PORTLAND HARBOR RI/FS

**APPENDIX H**

**EPA REVIEW OF EXISTING AND HYDRODYNAMIC AND  
SEDIMENT TRANSPORT MODEL**

**FEASIBILITY STUDY**

Figure H2-1c. Comparison of Measured and Predicted Changes in Sediment Bed Elevation on a SDU Basis

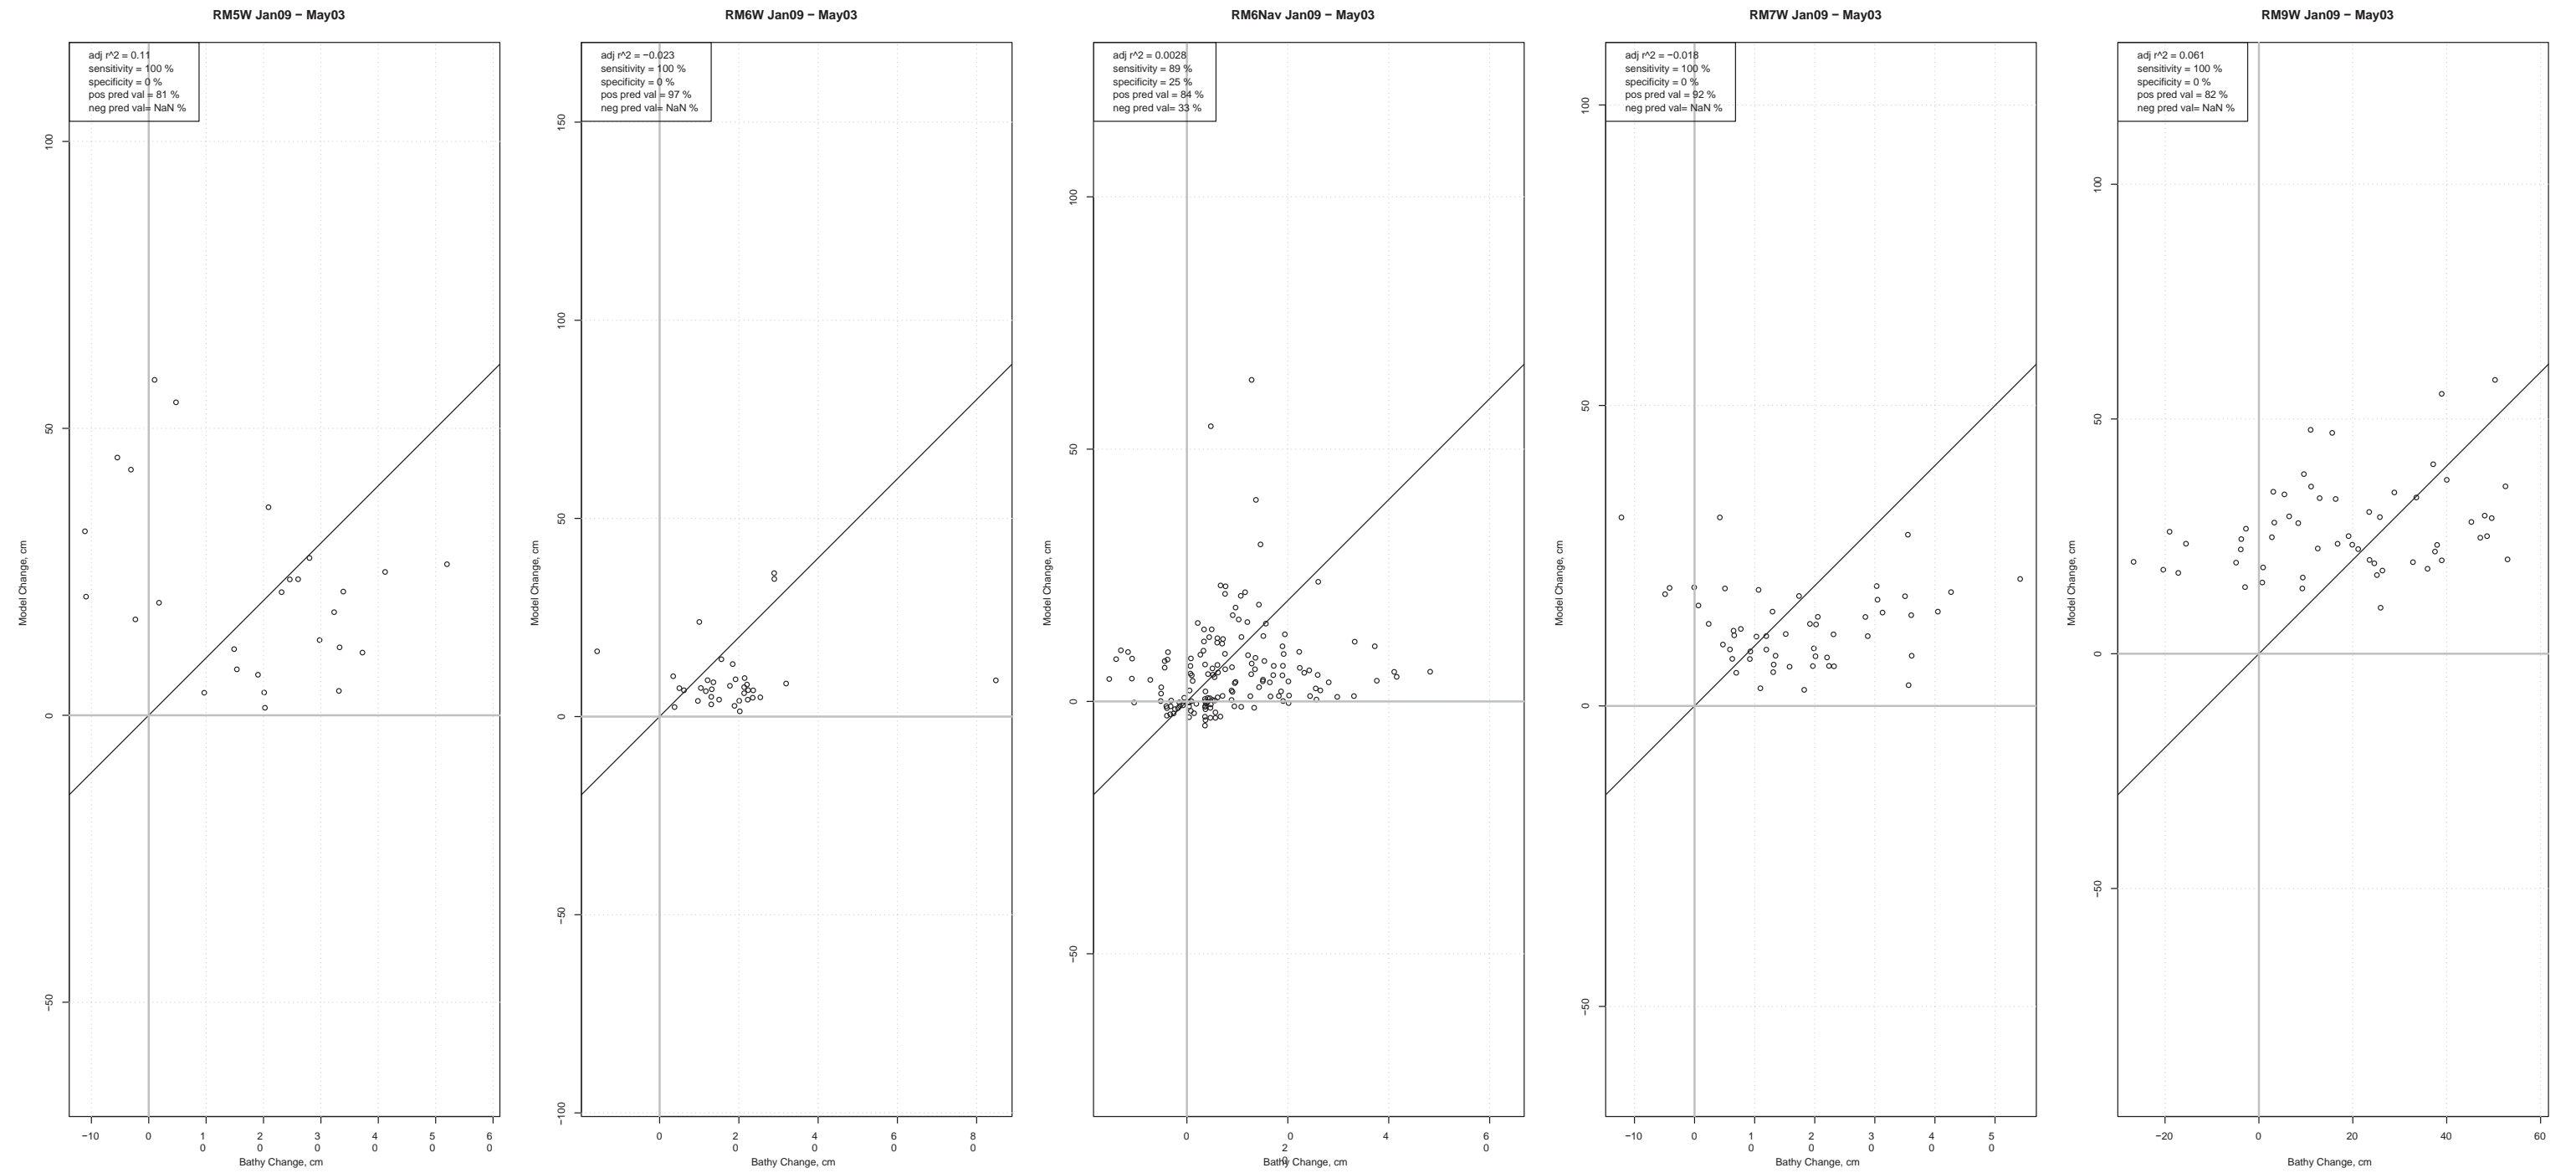
This evaluation indicates that the model predicts deposition the majority of the time. Erosion is predicted only within SDUs RM 5.5E, RM 6.5E, RM11E and RM6 Nav. However, measured changes in bathymetry indicate that some erosion was observed within every SDU. In addition, the plots did not correlate well with the 1:1 line which would indicate a good correlation between predicted and measured changes in sediment bed elevation. Adjusted  $r^2$  values range from 0.0028 to 0.42 with an average  $r^2$  of 0.093. SDU RM 2E ( $r^2 = 0.42$ ) and RM 3.9W ( $r^2 = 0.38$ ) exhibited the best correlation between measured and modeled results. Although deposition is under-predicted in some SDUs as evidenced by a greater number of points below the 1:1 line (RM 2E, Swan Island, RM 3.9W, RM 5W, RM 6W, RM 6NAV, and RM 7W), this is a result of the magnitude of the predicted deposition in comparison to the magnitude of the measured deposition. Only in SDUs RM 5.5E, RM 6.5E, RM 11E and RM 6Nav does the model predict erosion when deposition is observed (lower right quadrant). Conversely, the model predicts deposition when erosion is observed in every SDU.

These conclusions are supported by the positive and negative predicted values included **Figure H2-1**. Positive predictive values measures the percentage of positive predictions for which there actually was a positive response. In this case, the evaluation considers the percentage of time deposition was predicted when deposition was measured. Positive predictive values are greater than 50 percent - ranging from 57 percent to 97 percent - for all SDUs. However, the negative predictive power – which measures the percentage of time erosion was predicted when erosion was measured - is below 50 percent for all SDUs, with a maximum negative predictive value of 33 percent in SDU RM6Nav. As noted above, because the model failed to predict erosion in all but four of the SDUs, negative predictive values can only be calculated for 4 SDUs.

Overall, the results of this analysis suggest that the Portland Harbor HST model tends to over predict deposition, particularly in areas where erosion is measured. As a result, the utility of the contaminant fate and transport model developed for the Site to evaluate MNR is limited.
